WIZARDS WORKSHOP

TEKTRONIX INTERNAL USE ONLY

Published by Service Administration Support,
d.s. 56-037, ext. 642-8940

TSG 13

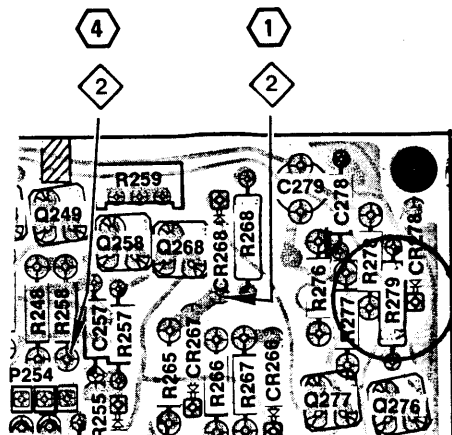
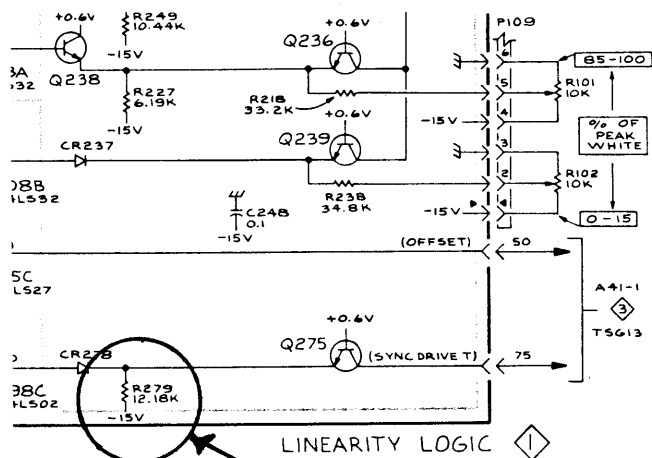
A possible problem has come to light
where the sync pulses are very close to
specified limits, creating the need to
adjust other amplitudes to slightly
out of position.

To correct this, change R279 from a 321-
1711-04 to a parallel combination of
two resistors, 321-1705-04 and 321-0147-
00. The new resistor added (321-0147-00)
is to be designated as R289.

Add: R279 321-1705-04
(13.05K)

R289 321-0147-00
(215K)

PARTS LOCATION GRID
SYNC GENERATOR ASSEMBLIES 670-4553-03
AND 670-4553-04 CHANGING TO 670-4553-05 AND 670-4553-06 RESPECTIVELY

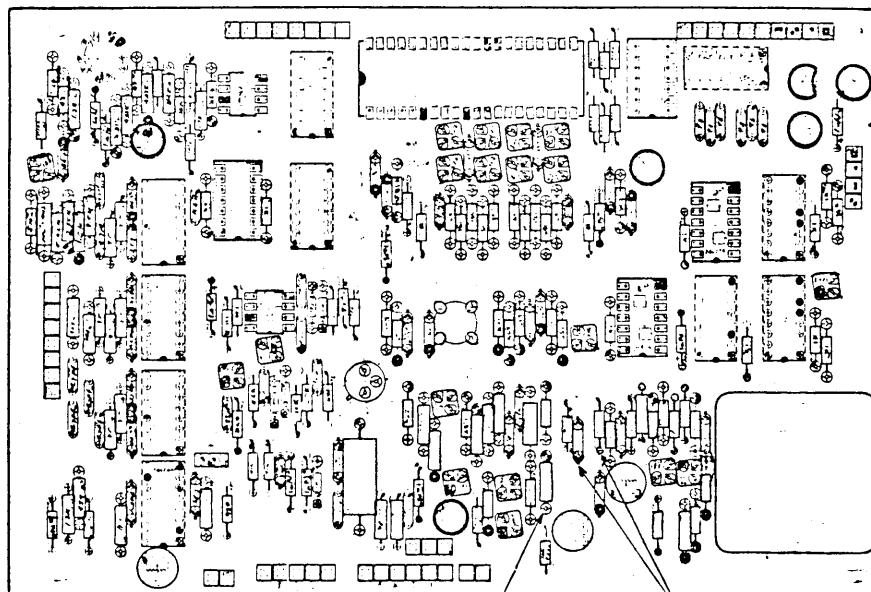
To allow the black burst adjustment (sub-carrier amplitude, R230) to be made more to the center of R230's rotation, R229 can be changed from the present 11.0K resistor to a 12.7K 1% resistor, 321-0299-00.

To assure that the subcarrier frequency remains constant when the front panel SUB-CARRIER switch is exercised in the internal mode with no Gen Lock signal applied to the rear panel, a 220pf capacitor (C237) can be added to the sync board as shown in the following diagrams.

CHANGE R229 FROM
321-0293-00 (11.0K, 1%)
TO 321-0299-00 (12.7K, 1%)

ADD C237 283-0108-00
(220pf, 10%) FROM
LEAD OF C229 TO LEAD
OF R237

DL11-W TERMINAL INTERFACE MODS

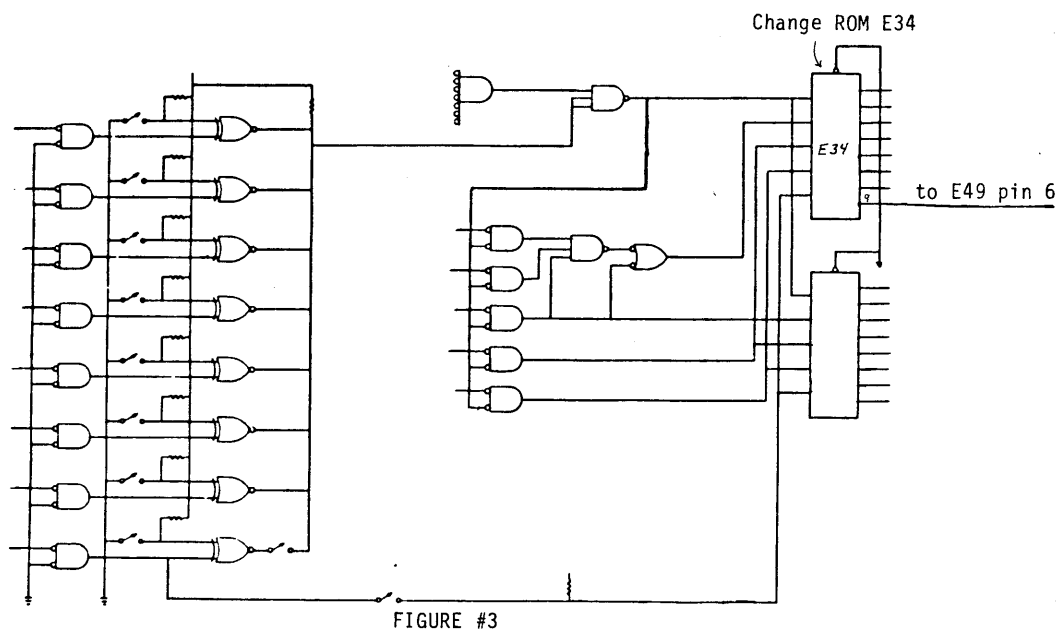
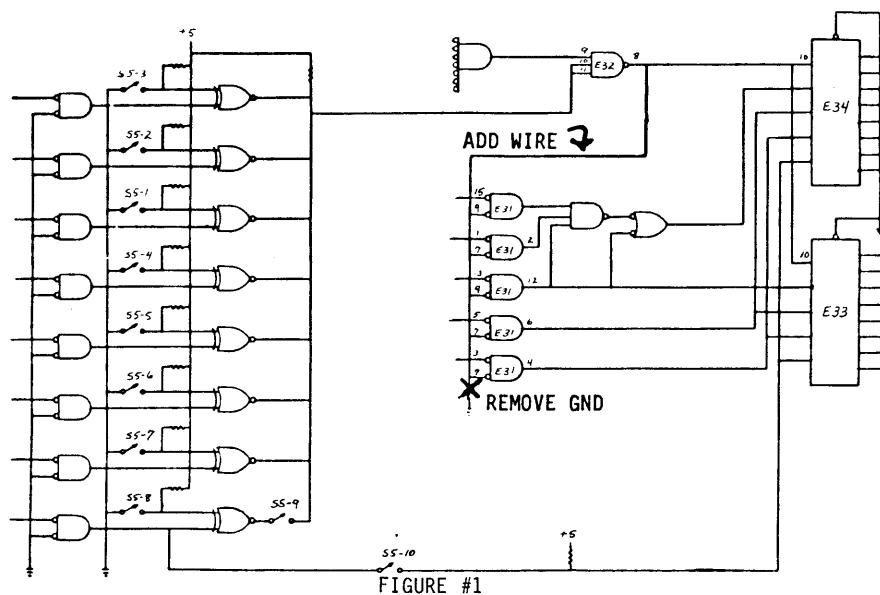
1. See figure #1 for mod. On side one (component side of DL11-W), lift legs 7 and 9 of E31.
2. Connect legs 7 and 9 of E31 to leg 8 of E32 using small insulated wire.

A DL11-W terminal interface that supports a Tektronix 4006 terminal is modified to include the circuits shown in figures #2 and #3. Also, the data stored at location 22 octal of ROM E34 is changed from 00011100 to 10011100 (34 octal to 234 octal). This is done by replacing

1. Exchange ROM E34 for ROM with correct firmware. Address 22 of E34 is 10011100 instead of 00011100.
2. Install wire from pin 9, E34 to pin 6, E49.
3. Install wire from pin 13, E49 to pins 11, 12, E58.
4. Install wire from pin 13, E58 to pin 5, E49.
5. Install wire from pin 4, E49 to S-2 switch 1. (Pin 16)
6. Install wire from S-2, switch 1 to pin 1, E14. (Pin 1)

FIGURE #4

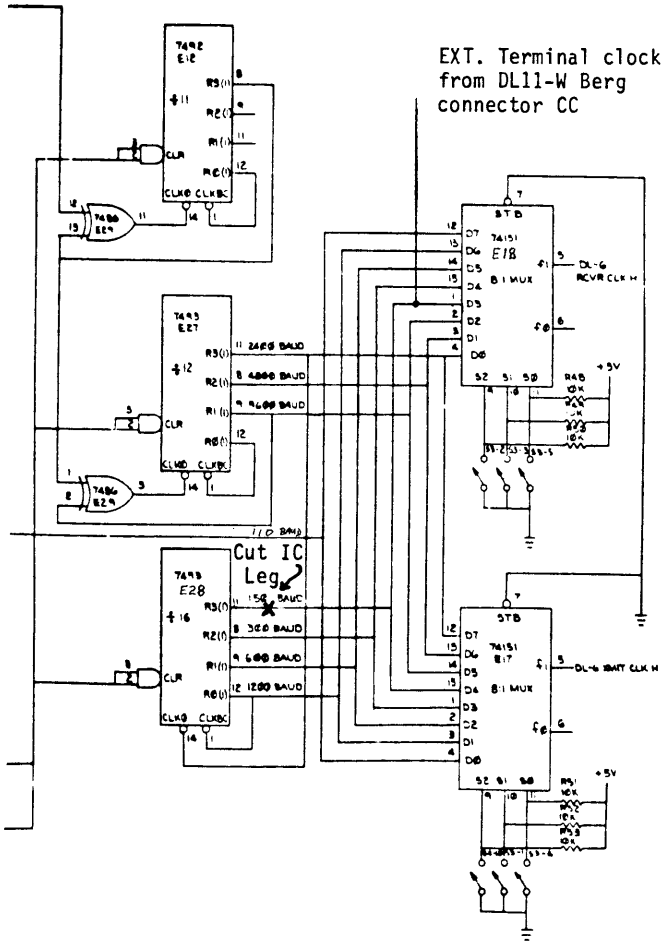
1. Cut pin 11 of E28.
2. Install a wire from the DL11-W berg connector pin CC to pin 1 of E18. Install the wire on the back of the board. See Figure #4.

4611/4054: GRAPHIC SYSTEM HANGS WHEN
COPIER IS TURNED OFF

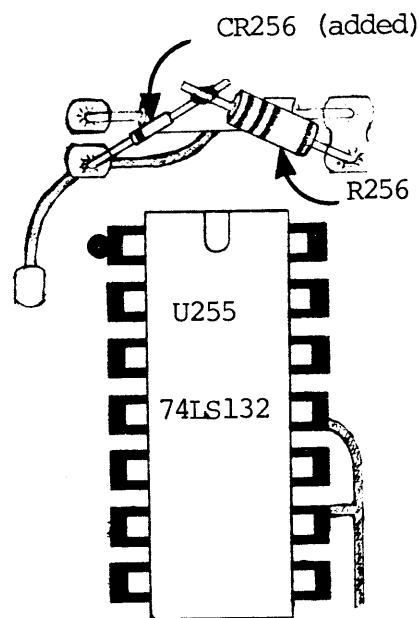
The 4054 will hang busy when connected to a 4611 that is powered down. The problem is fixed by a mod to the 4611 DVST Interface Board, P/N 670-5756-00. All 4611s with S/N B010765 and above have this mod installed.

- Disconnect power and remove the DVST Interface board from the unit.
- Locate U255 and R256 just above it.
- Lift the left end of R256.
- Solder in a diode (P/N 152-0141-02) cathode down, in series with R256. See illustration.

The part number suffix of the board rolls to 670-5756-01.
